Consultation on Lower Queen Street (Northcote Point) Speed Calming Measures

Your feedback

During October and November 2016, Auckland Transport (AT) asked for your feedback on options for speed calming measures along lower Queen Street, Northcote Point.

Figure 3 Locations for speed calming measures along lower Queen Street, Northcote Point

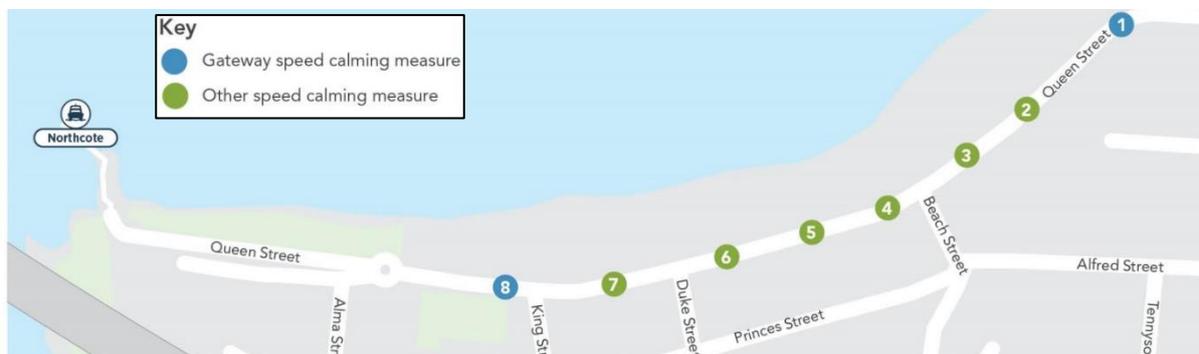
Respondents who did not support this option expressed concern that the design would not improve safety for pedestrians or those who cycle. A couple of respondents expressed specific concern regarding the proximity of location 1 to the blind bend.

- *“There is no need for the measure, and gateway 1 is on a blind bend. If anything this would be the road less safe.”*
- *“This option will not result in sufficient speed reductions.”*
- *“Design will not meaningfully increase safety or comfort of cyclists.”*
- *“Traffic calming does not make a safe cycling space - cyclists remain at risk from doors opening and do not have a protected area to ride in”.*
